Proposal for draft amendments to Regulation No. 94- Rev. 1

Submitted by the expert from France

The text reproduced below was prepared by the expert from France in order to extend the scope of the present Regulation to all kinds of power train systems above a certain working voltage level. The modifications to the existing text of the Regulation R 94 are based on discussions made at the EVPC adhoc group meeting held in Paris at 13-14 January 2010, and supersedes document No.GRSP/46-04e distributed as a document without symbol (informal document) during the forty-sixth session of the Working Party on Passive Safety (GRSP). The modifications to the existing text of Regulation No. 94 are marked in bold or strikethrough characters.

Figure 4: Measurement of high voltage bus energy

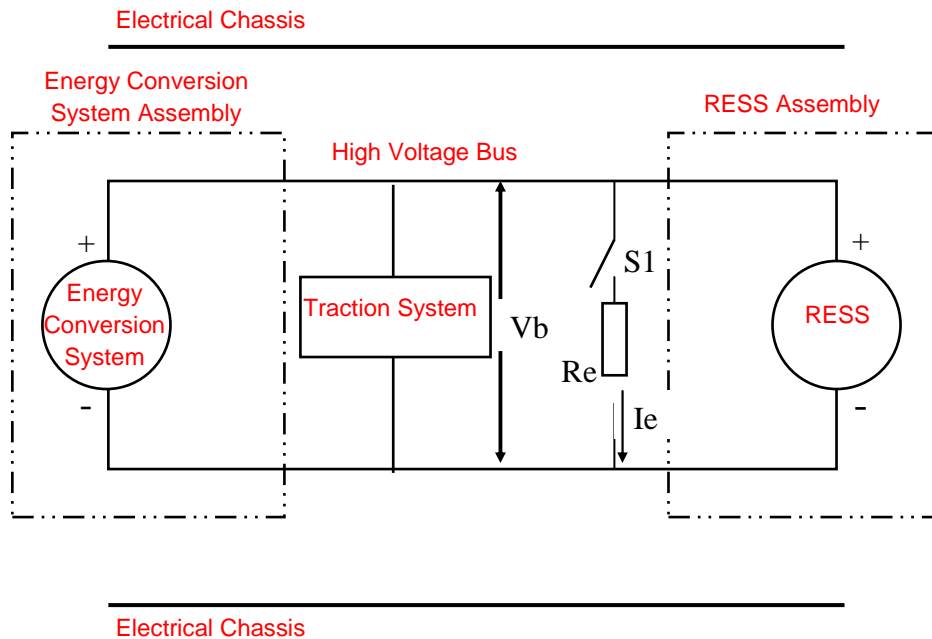
Prior to the impact a switch S1 and a known discharge Resistor Re is installed according to Figure 4. **At 5 seconds** **At As soon as possible after 5 seconds** after the impact the Switch S1 is closed while the voltage Vb and the current Ie is measured and recorded. The product of the voltage Vb and the current Ie is integrated over the period of time starting
